D7 V1.4 upgrading pack

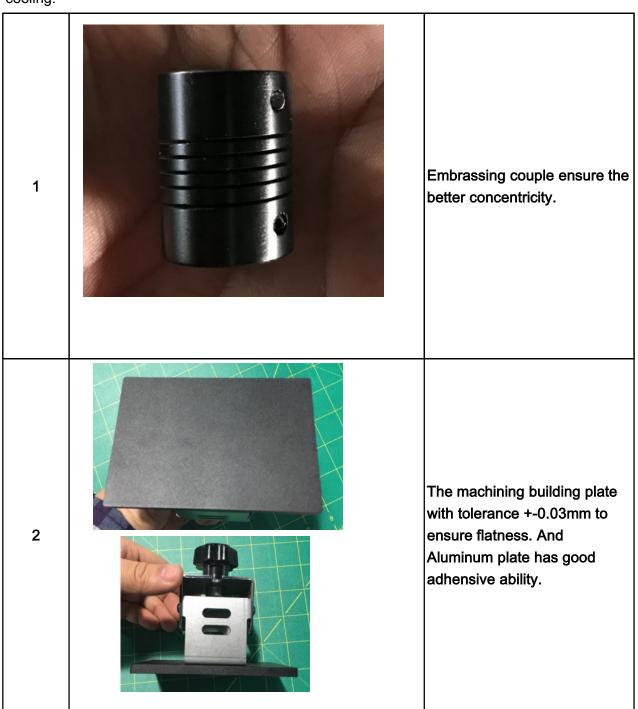
Anti-backlash Brass Z axis nut to make Z axis movement more precise.
